**BEFORE THE PUBLIC UTILITY COMMISSION
OF OREGON
UE 356**

REDACTED OPENING TESTIMONY
OF THE
OREGON CITIZENS' UTILITY BOARD

June 10, 2019

1 Here is the chart for hourly prices at the California-Oregon Border (COB)⁹:

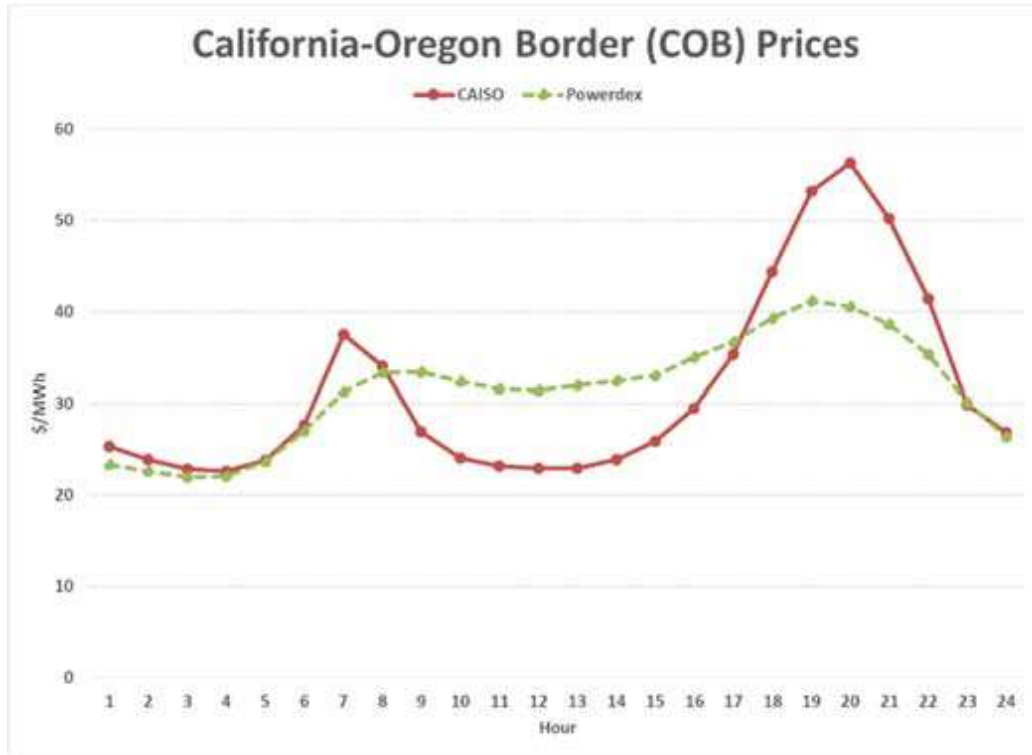
9 **A.** The Company compares the scalars using the historic PowerDex methodology and
10 its new CAISO methodology and then asserts that “as seen in the charts, the
11 updated scalars (red line) produces a more reasonable shape.⁸” The Company
12 claims that with increasing solar penetration the CAISO methodology “better
13 reflects” market conditions. But it offers no empirical evidence that the CAISO
14 methodology produces a better price forecast.

3 The Company believes it is obvious that the red line is more accurate. The red line
4 certainly reflects California's Duck Curve, which has a significant effect on
5 California prices. However, if net load doubles between midday and early evening,
6 this does not mean that prices double. Much of the price response will depend on
7 available capacity. The green line in the chart may better represent the prices during
8 periods of available capacity.

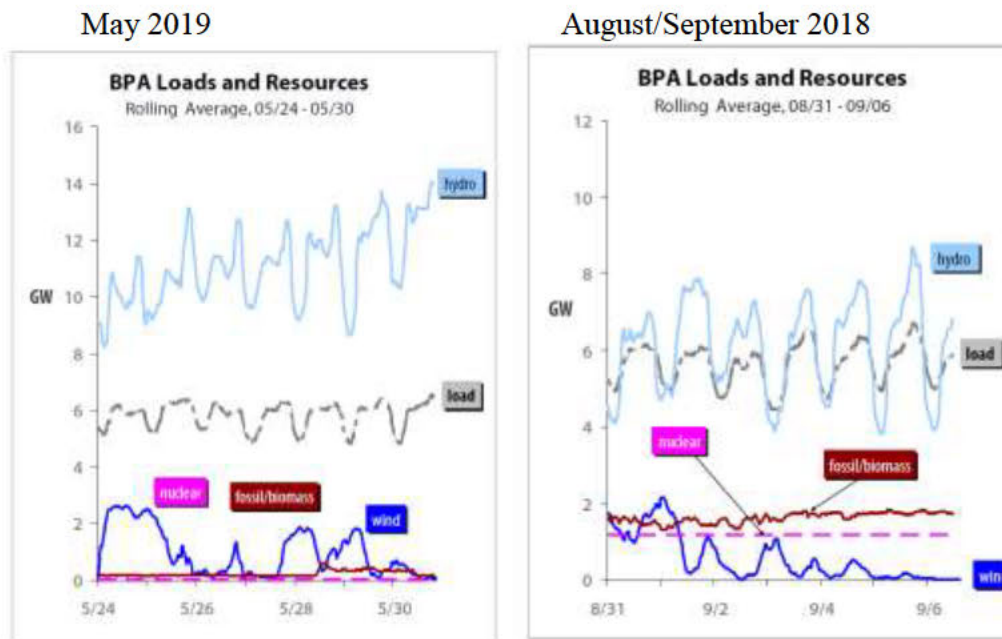
12
13 Consider hydro conditions. Below are two charts from Clearing Up which show
14 BPA’s loads and resources.¹¹ The first is from the last week of May of 2019 and
15 the second is from a week that straddles August/September of 2018. In May of
16 2019, the hydro line is well above BPA’s load which means that the hydro system
17 has excess capacity that is being used to respond to regional loads. At the end of
18 the summer in 2018, hydro capacity was much more limited and hydro production
19 was not well above BPA’s load. In turn this hydro capacity affects prices.

2 Hydro doesn't just vary by season; it varies significantly by year. Using a single
3 year of data, means that a single year of hydro is used. CUB is concerned that the
4 scalars based on a single year will not reflect normalized hydro conditions which is
5 important when forecasting prices in the Pacific Northwest.
